METROPOLITAN GOVERNMENT OF NASHVILLE AND DAVIDSON COUNTY

STAFF RECOMMENDATION
2020 10th Avenue South
October 16, 2019

Application: New Construction—Outbuilding (Detached Accessory Dwelling Unit)
District: Waverly-Belmont Neighborhood Conservation Zoning Overlay
Council District: 17
Map and Parcel Number: 10509041200
Applicant: William Smallman
Project Lead: Melissa Sajid, melissa.sajid@nashville.gov

FRONT (CLAYTON) ELEVATION

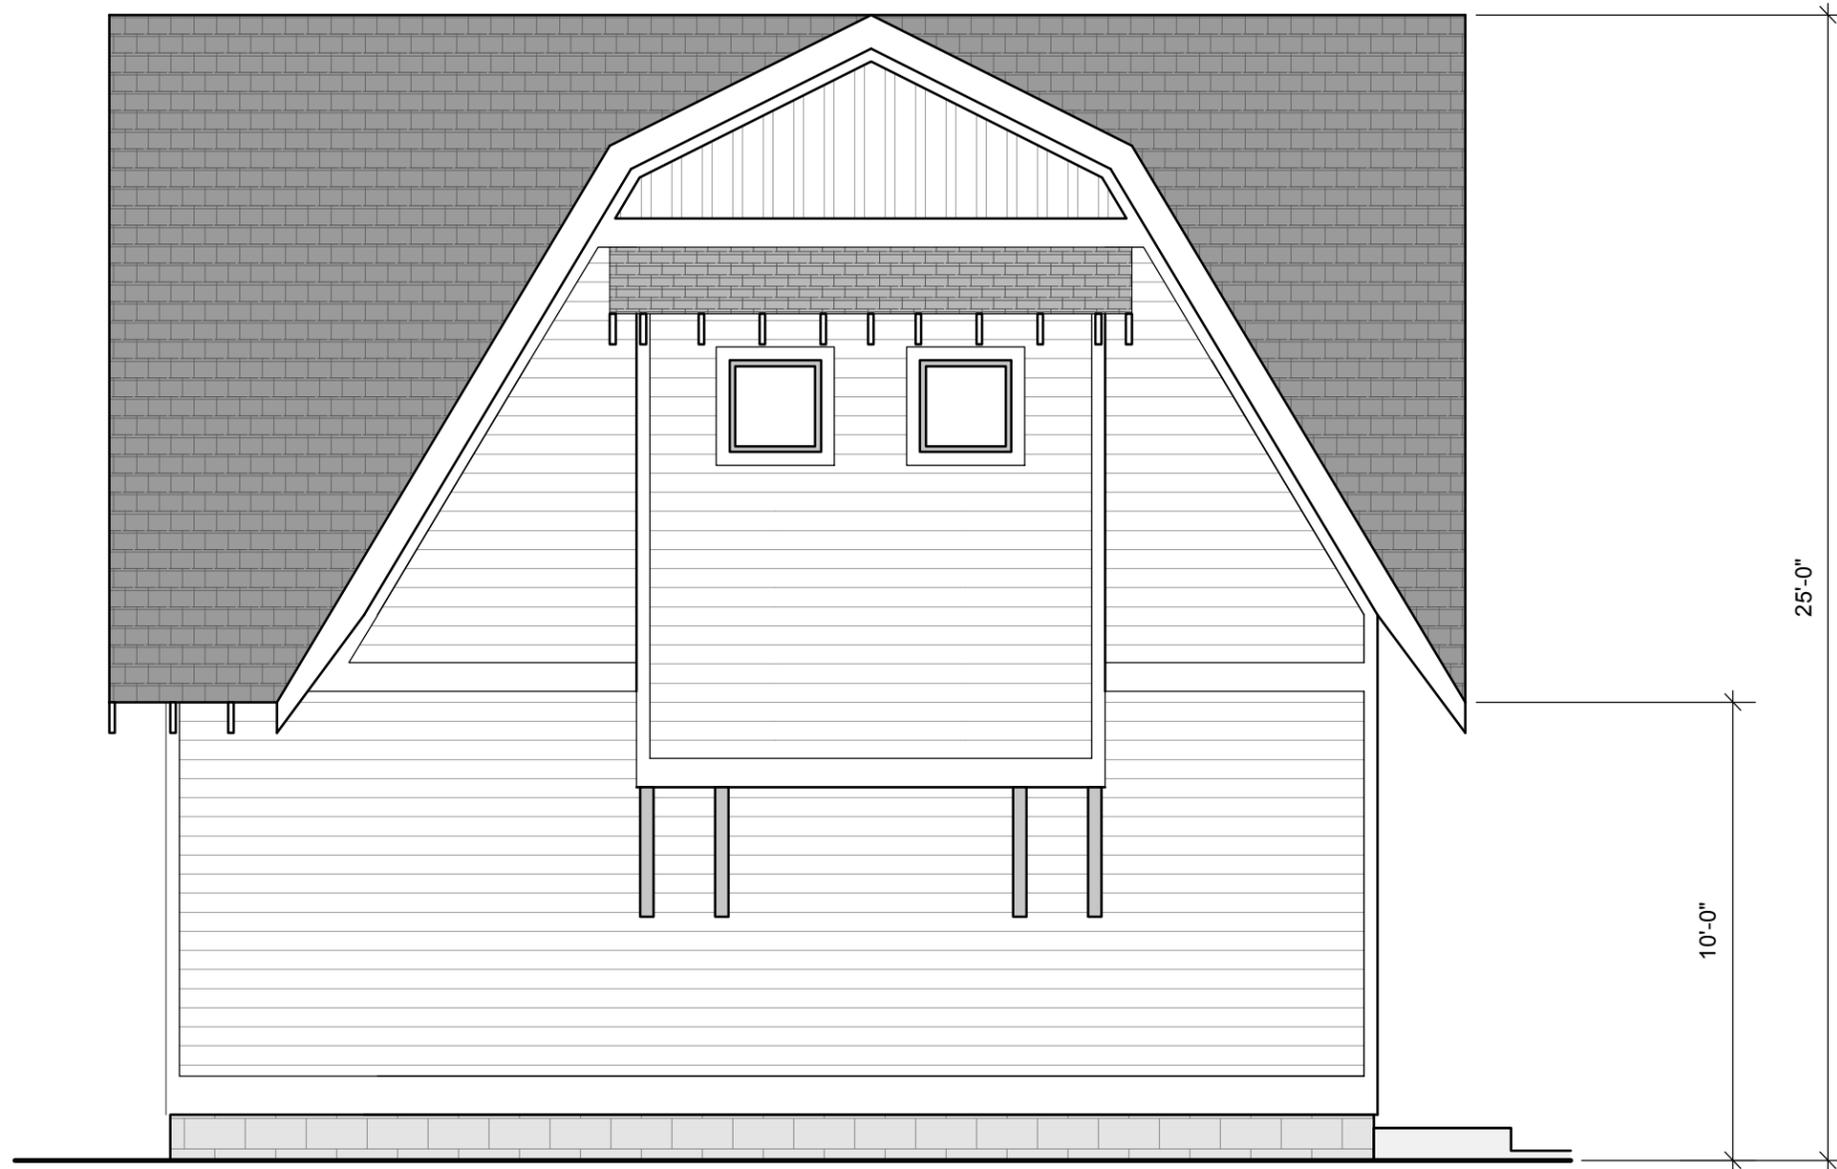
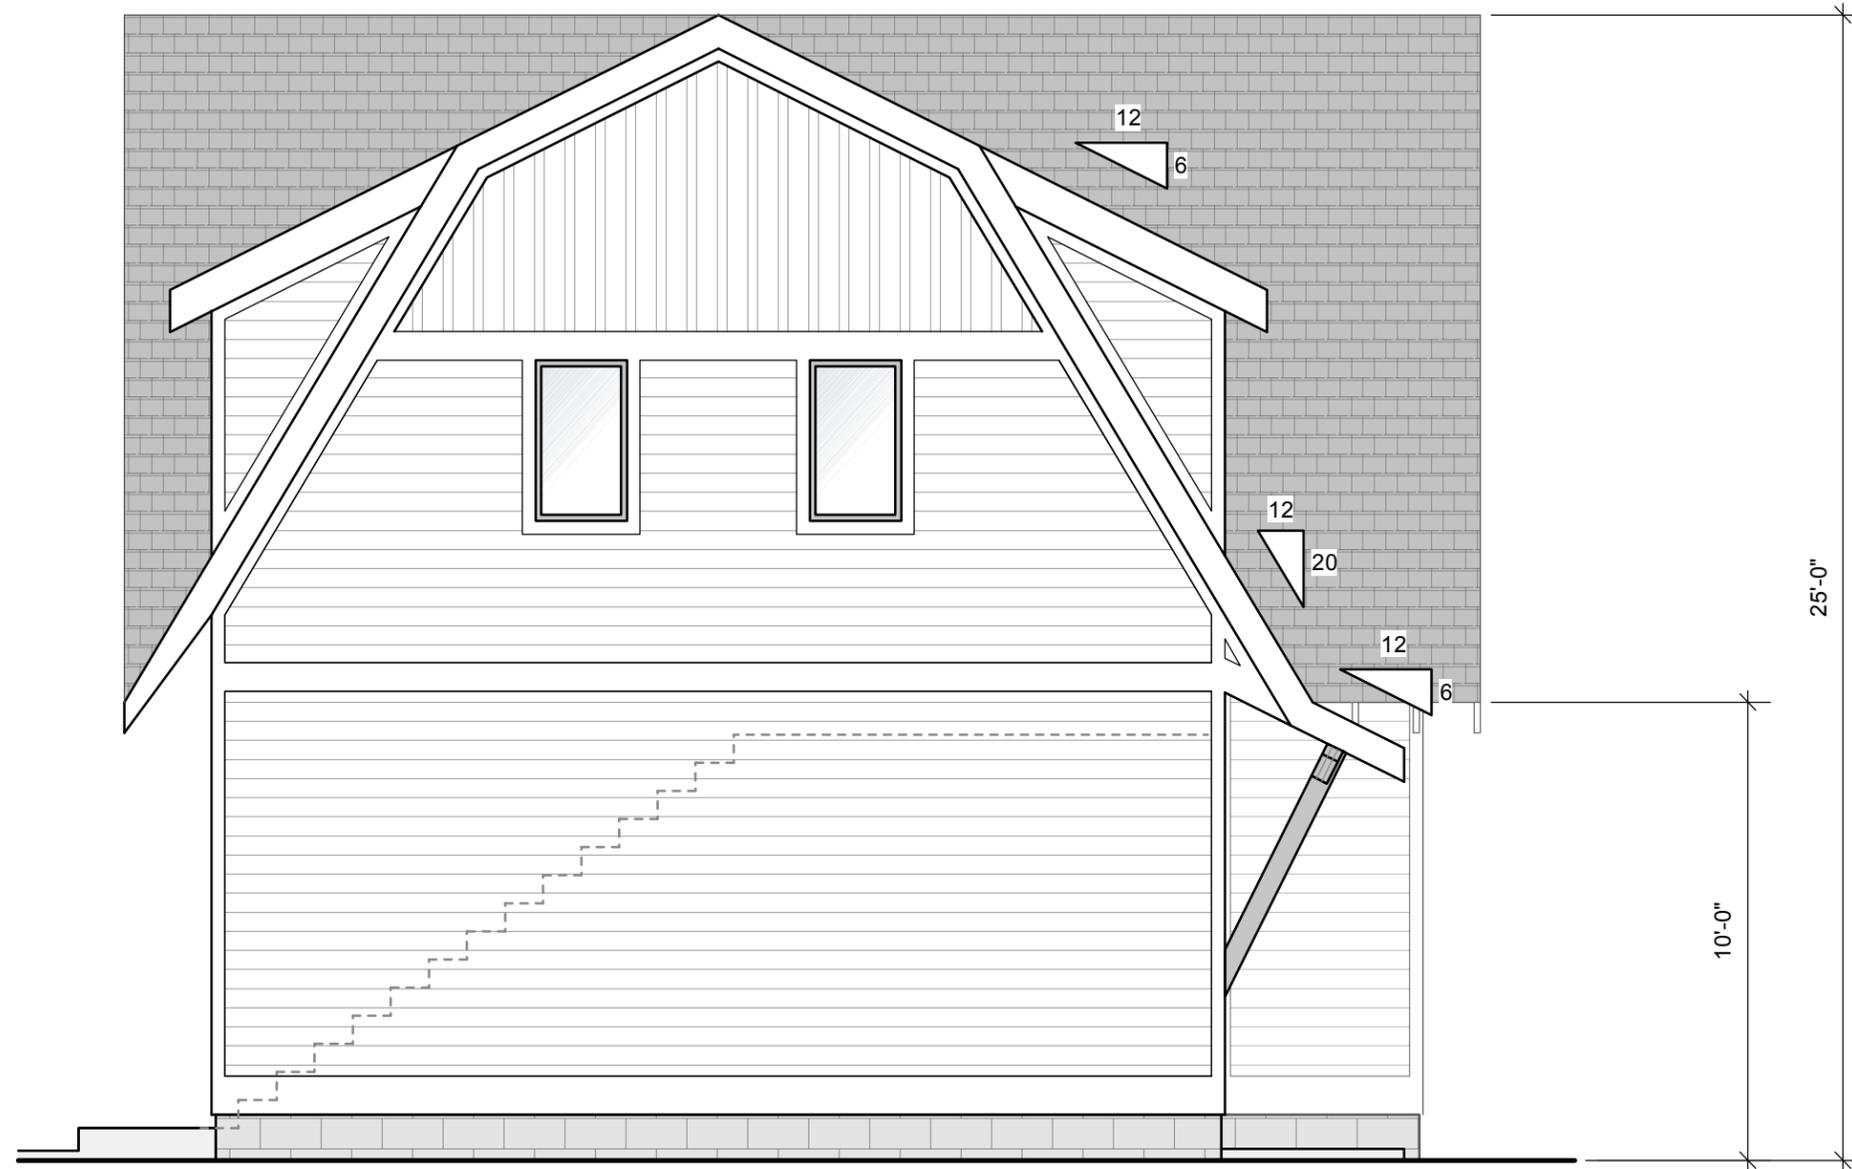
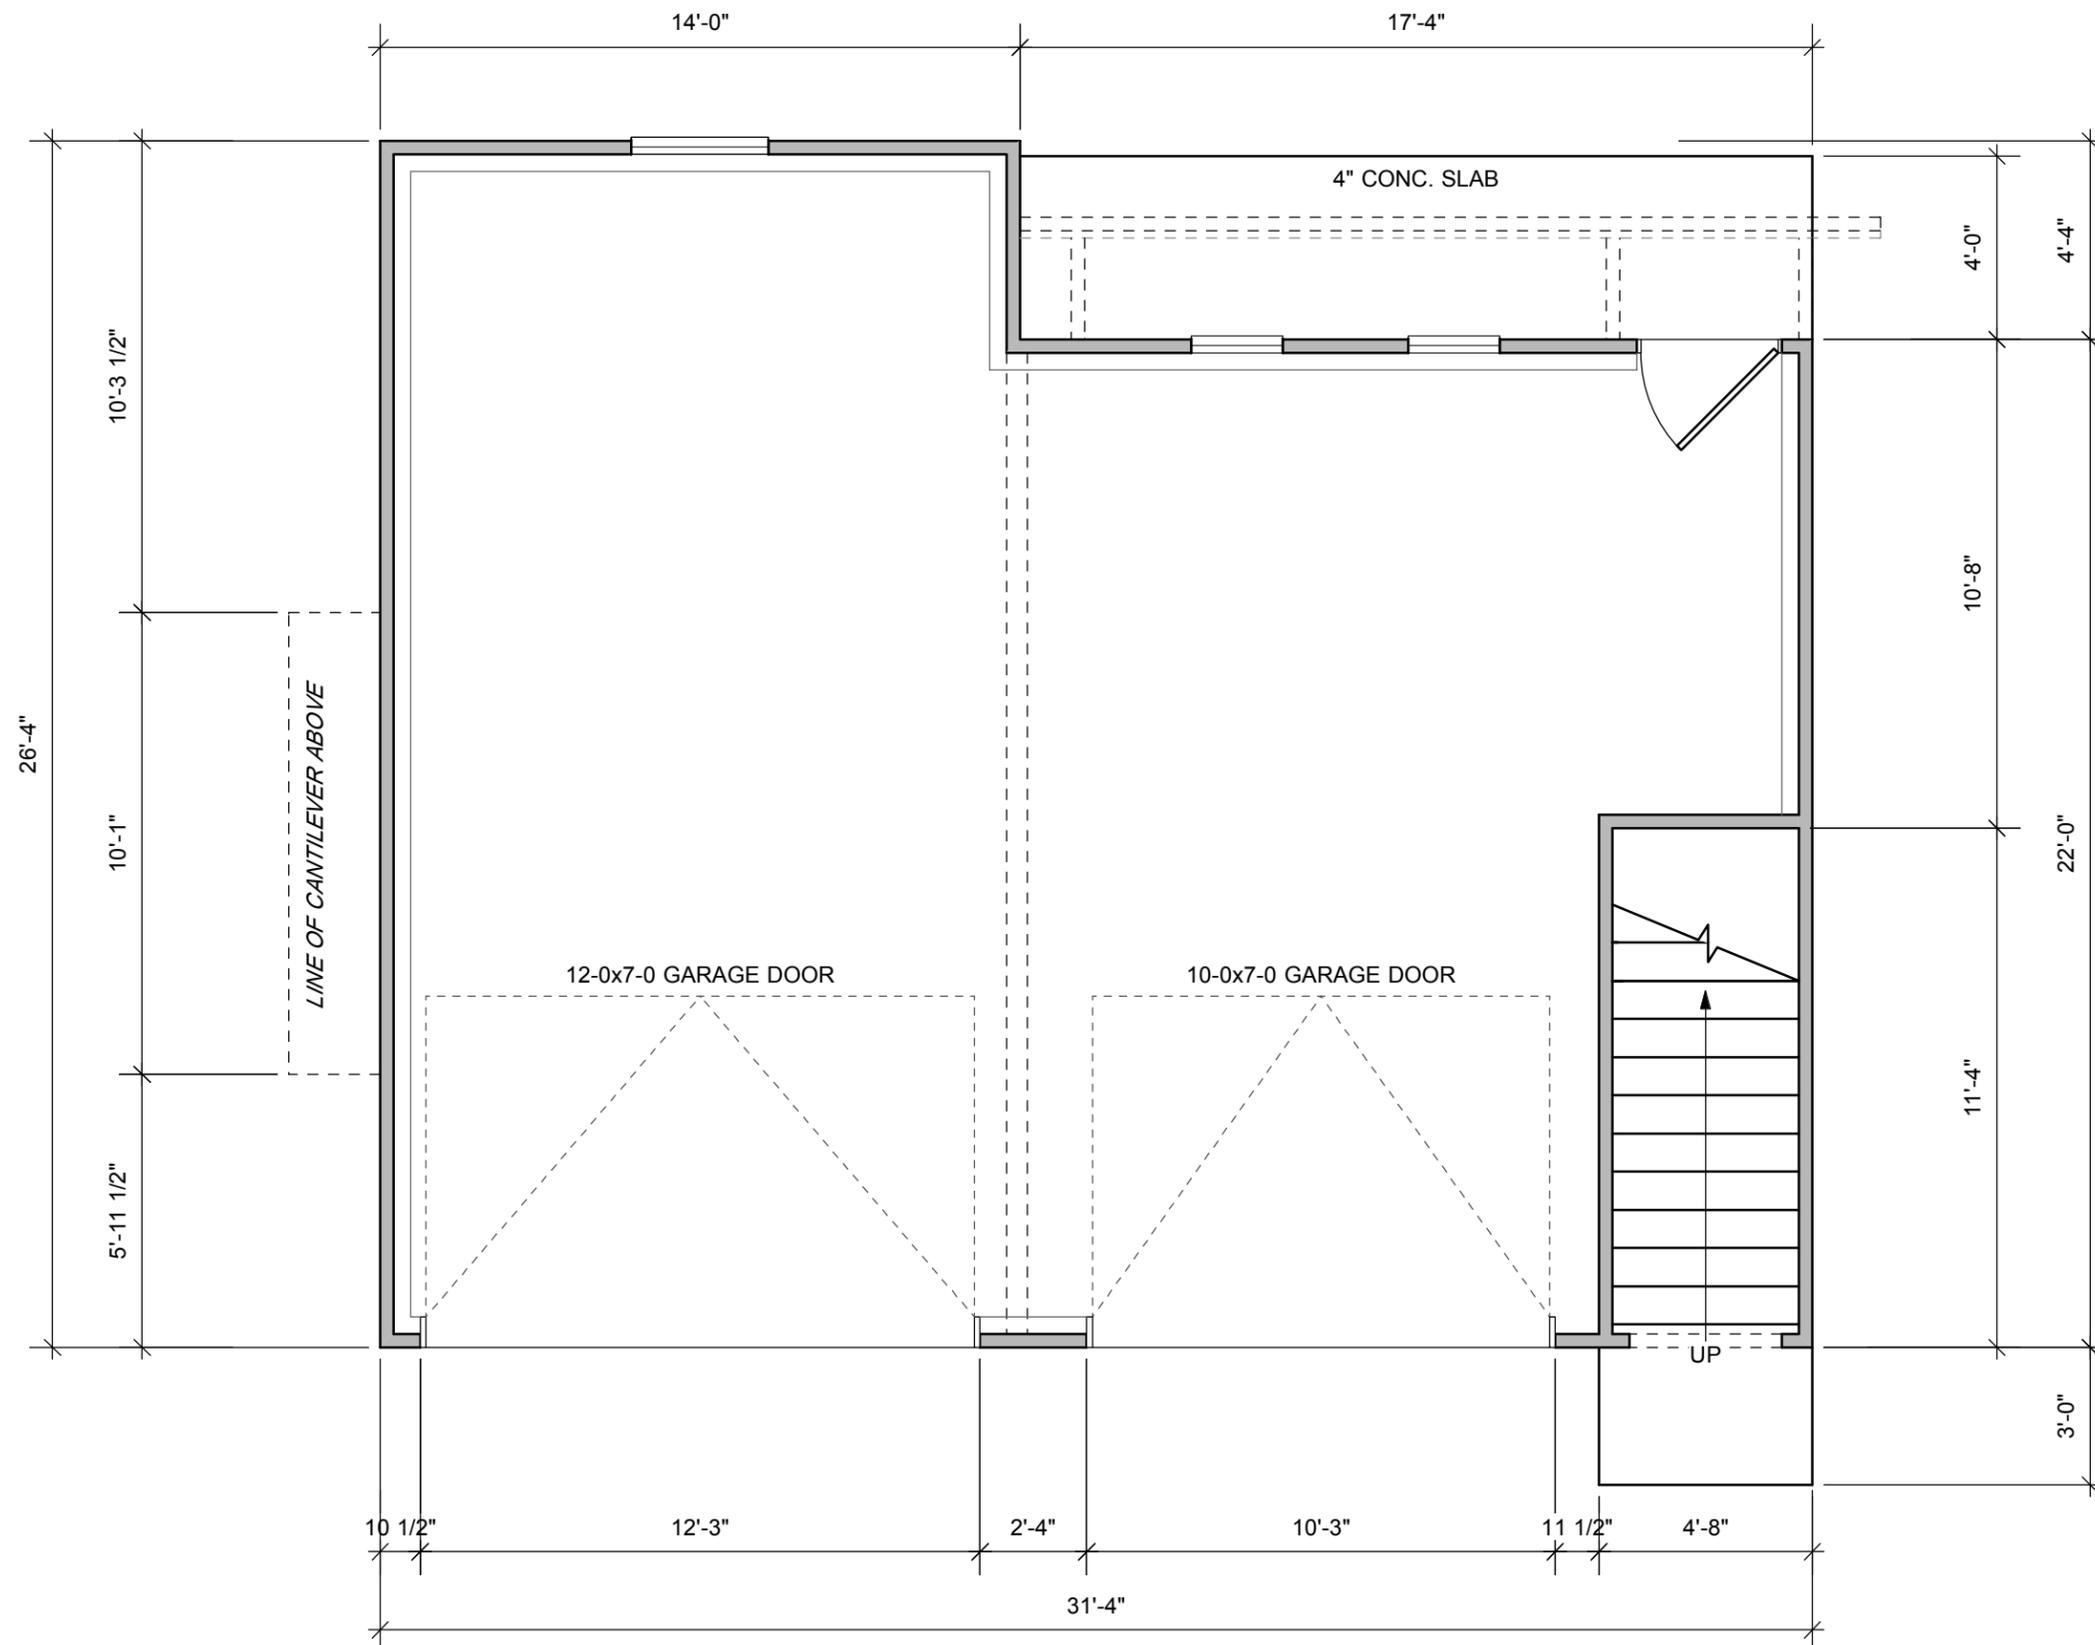
The proposed outbuilding exceeds the height of the historic house. The historic house is approximately eighteen feet (18') tall from finished floor, and the approved addition adds two feet (2') for a total of twenty-feet (20'). The outbuilding is proposed to have a height of twenty-five feet (25'). In order to meet the design guidelines, the overall height of the outbuilding must be reduced by at least five feet (5'), which would result in a complete redesign of the project.

For these reasons, staff finds that the project does not meet Section III.H.1.c of the design guidelines and Section 17.16.030.G.7 of the DADU Ordinance for height and scale.

The proposed outbuilding has a cross gable and gambrel roof form, which is not common in the neighborhood. Both gable roofs and gambrel roofs are seen historically and have been approved by the Commission in the Waverly-Belmont district and the neighboring Belmont-Hillsboro district. The outbuilding incorporates dormers on the front and rear elevations.

The dormers do not exceed fifty percent (50%) of the roof plane. The Commission has required dormers to sit at least two feet (2') back from the first-floor wall; however, on a gambrel form, that is not possible. The Commission has approved a couple of outbuildings that have a gambrel roof form with dormers that stack on the wall below, so staff finds that the proposed dormers stacking the wall below is appropriate in this case.

While the proposed roof form and slopes could meet the design guidelines, the overall height of the outbuilding exceeds that of the historic house. For this reason, staff finds that the project does not meet Section III.H.3 of the design guidelines for roof shape and Section 17.16.030.G.8 for design standards of the DADU Ordinance.
